SUBMITTAL IDENTIFICATION SHEET

WEBSTER UNIVERSITY ISB	
PROJECT NAME	
8274 BIG BEND BLVD	
ADDRESS	
NUMBER	
WEBSTER UNIVERSITY	
OWNER	
CANNON DESIGN	
ARCHITECT / ENGINEER	
DEVIN D GATES	
SUBMITTED BY	
123553-001 REV 2	
CONTRACTOR / CM SUBMITTAL NO.	CANNON DESIGN SUBMITTAL NO.
	123553
DRAWING / DETAIL REFERENCE	SPECIFICATION SECTION / PARAGRAPH
MANUFACTURER / SUPPLIER	ITEM / PRODUCT ID
REQUIRED DATE	PRIORITY
	CRITICAL

DATE: 1/25/2017
JOB: 04437A, B, C, D
RE: Webster University
Webster Groves, MO

6780VM

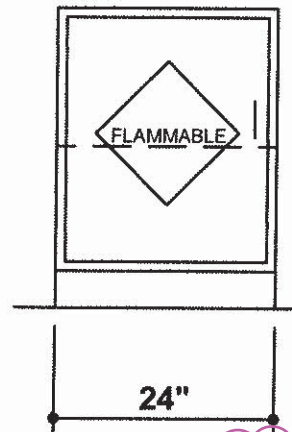
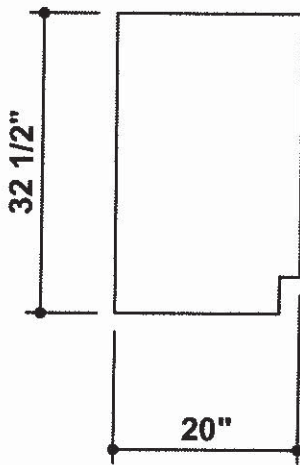
WILL BE PROVIDED AS INSET STYLE-
THIS IS THE ONLY OPTION.

A/E CONFIRM THIS IS
ACCEPTABLE

FLUSH WOOD FINISH,
OVERLAY DESIGN TO
MATCH ADJACENT
CABINETS

PROVIDE PER SPECIFICATION
123553, 1.7,E.

PROVIDE FM APPROVED, UL LISTED

6780VM1

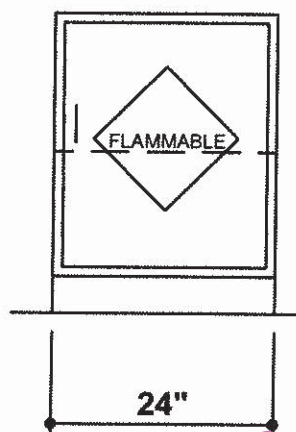
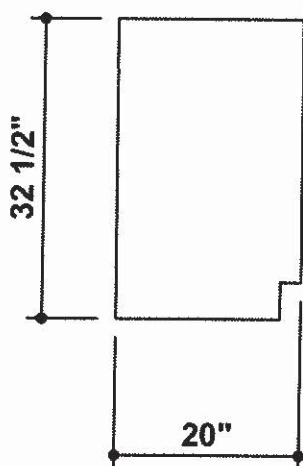
WILL BE PROVIDED AS INSET STYLE-
THIS IS THE ONLY OPTION.

A/E CONFIRM THIS IS
ACCEPTABLE

FLUSH WOOD FINISH,
OVERLAY DESIGN TO
MATCH ADJACENT
CABINETS

PROVIDE PER SPECIFICATION
123553, 1.7,E.

PROVIDE FM APPROVED, UL LISTED

6780VM2

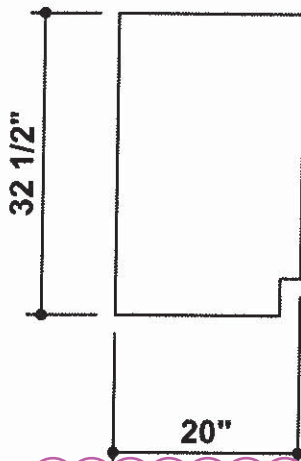
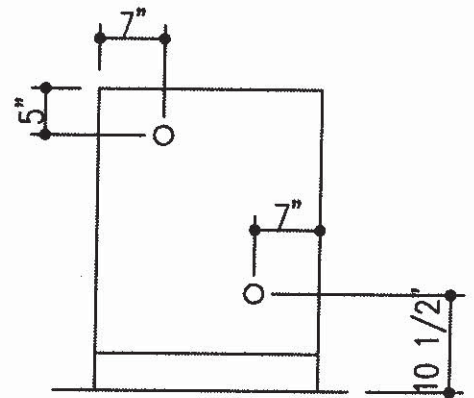
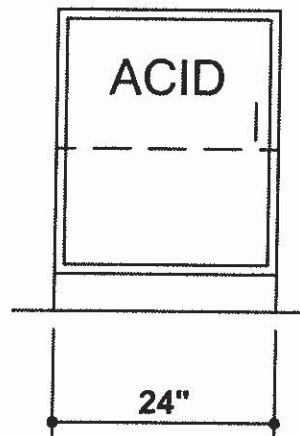
WILL BE PROVIDED AS INSET STYLE-
THIS IS THE ONLY OPTION.

PROVIDE PER SPECIFICATION
123553, 2.3.A.

A/E CONFIRM THIS IS
ACCEPTABLE

PROVIDE FM APPROVED, UL LISTED

VENT
LOCATIONS

PROVIDE WOOD FINISH,
FLUSH OVERLAY DESIGN TO
MATCH ADJACENT CABINETS

PROVIDED WITH 1/4" THICK
POLYPROPYLENE LINER
